Comments

Aquatic Aviary - PLAN

ZOOLOGICAL GARDEN; THIRUVANANTHAPURAM. KERALA

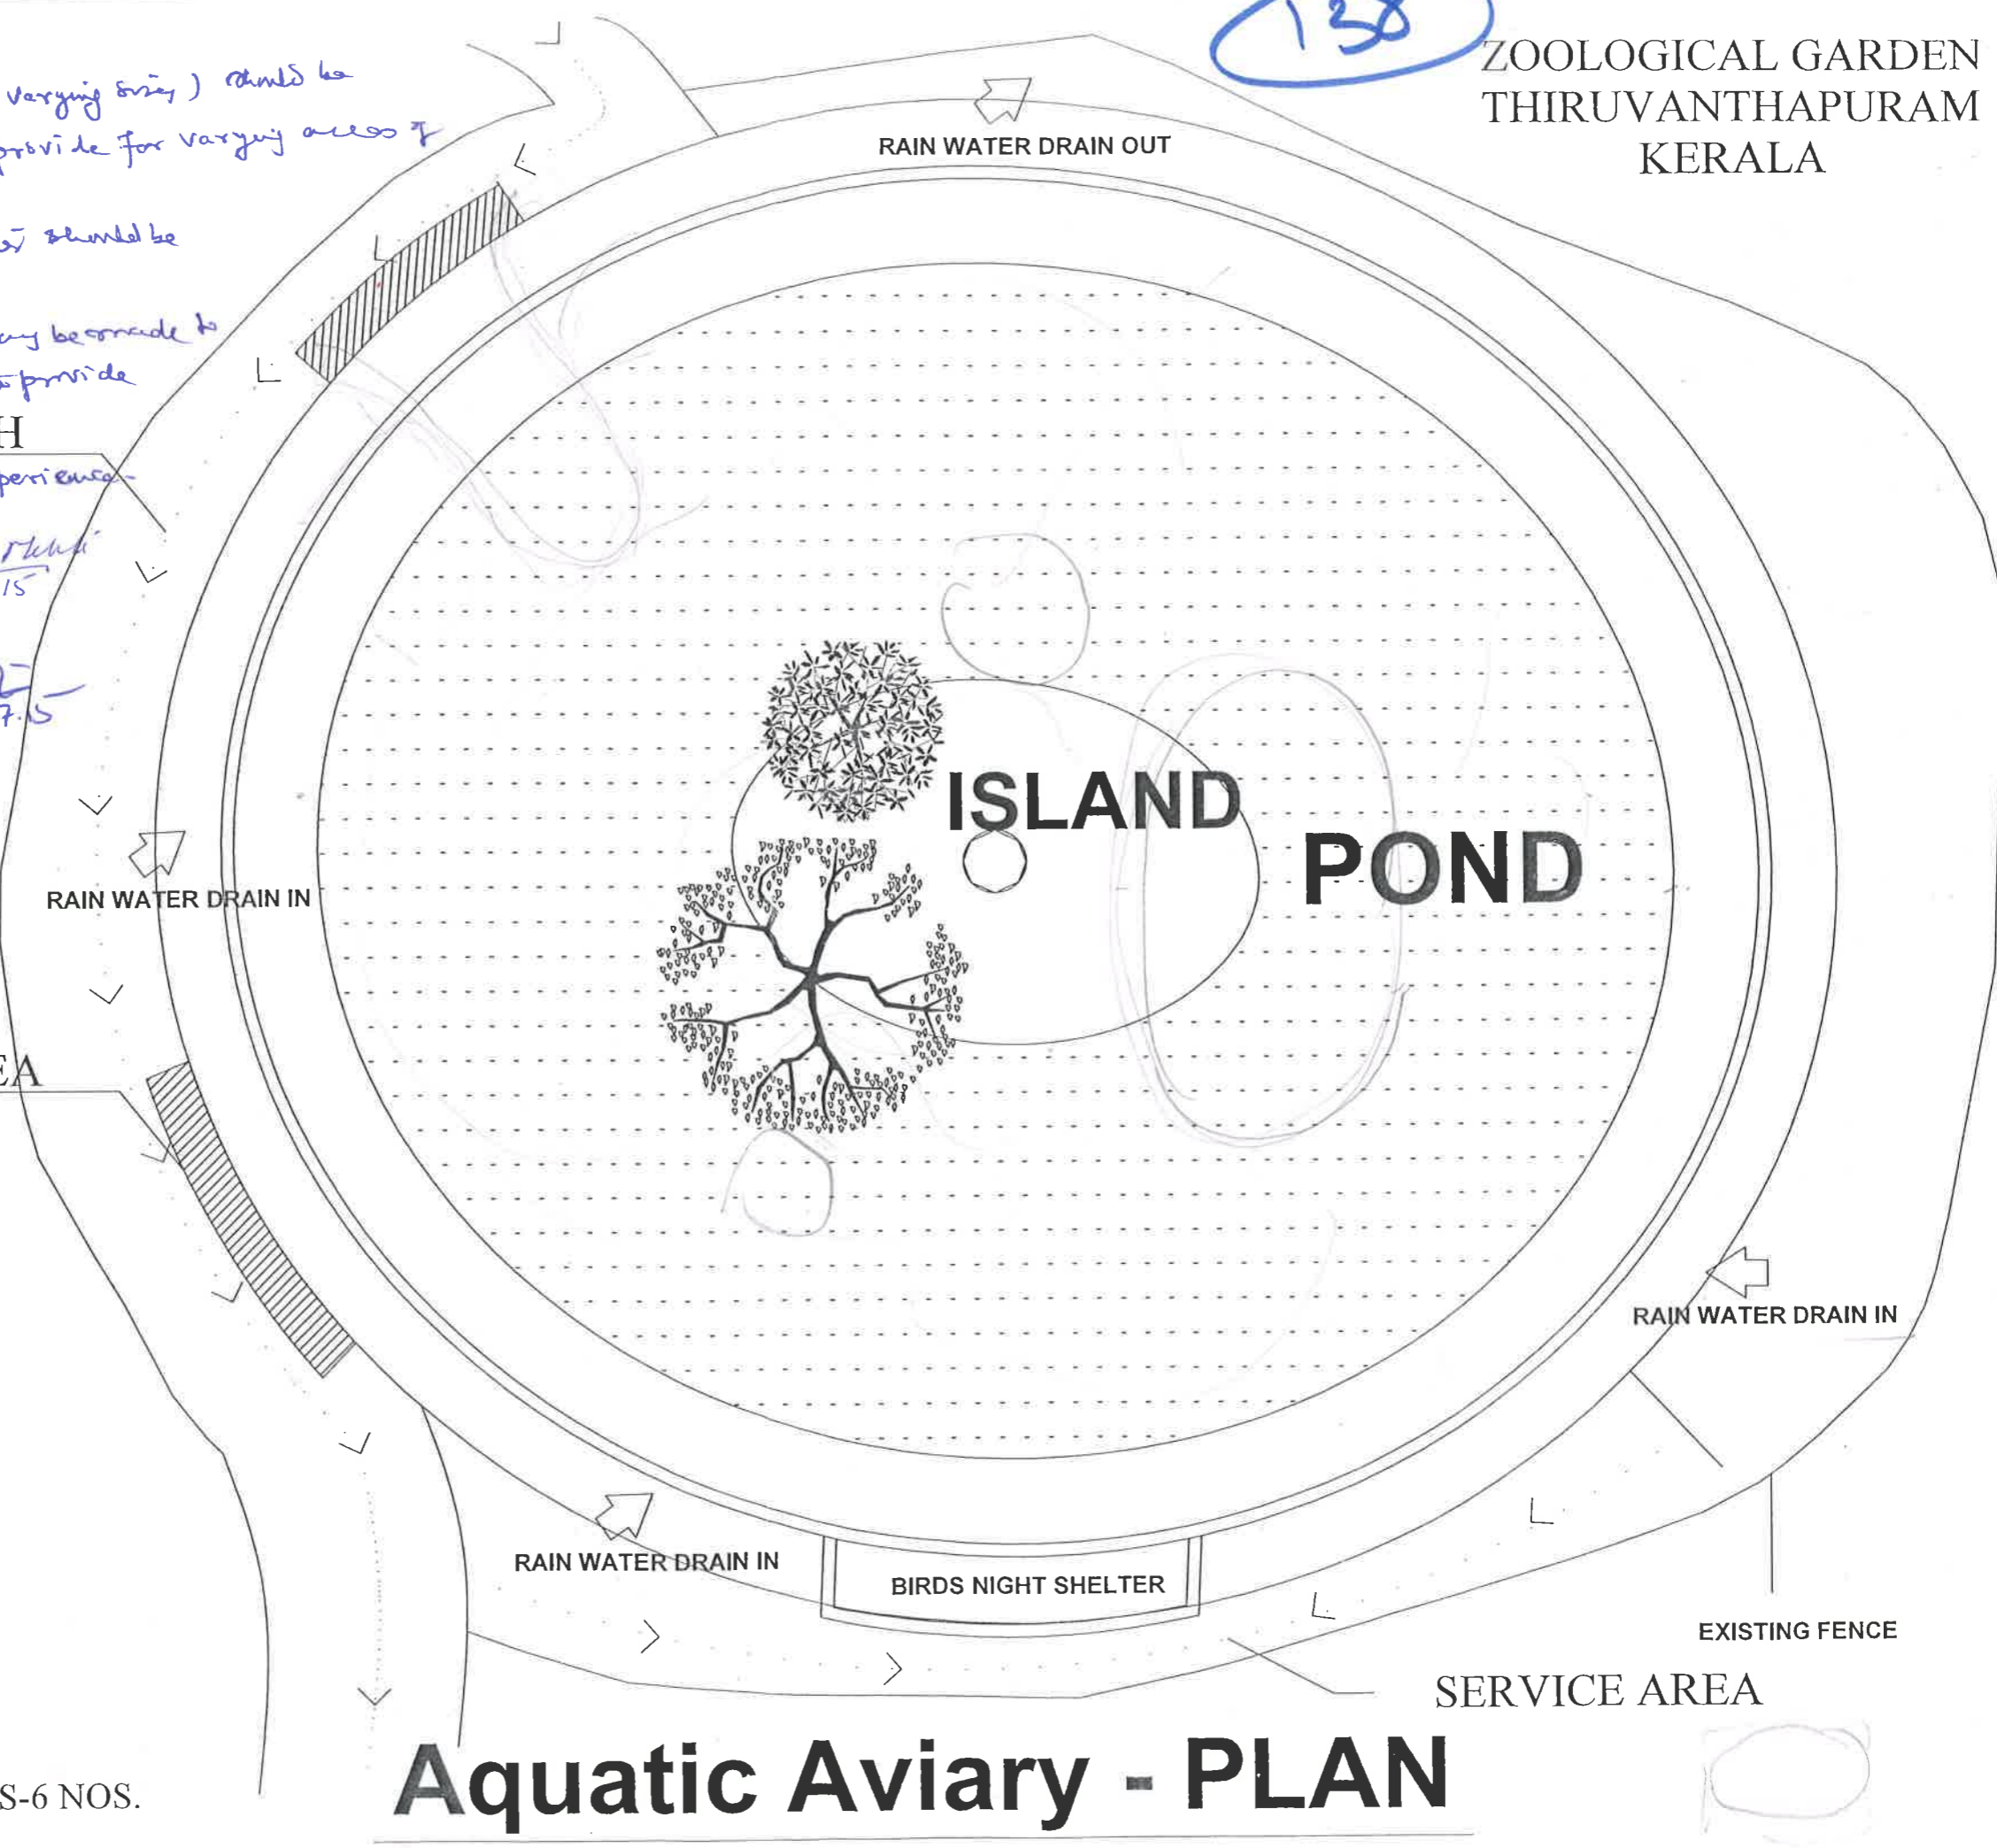
- ① The number of islands (of varying sizes) should be located asymmetrically to provide for varying access of water
- ② The depth of water at embankment should be between 1.5 to 2 mtr.
- ③ Part of viewing area may be made to intrude into the pond to provide immersion for ~~visiting~~ experience.
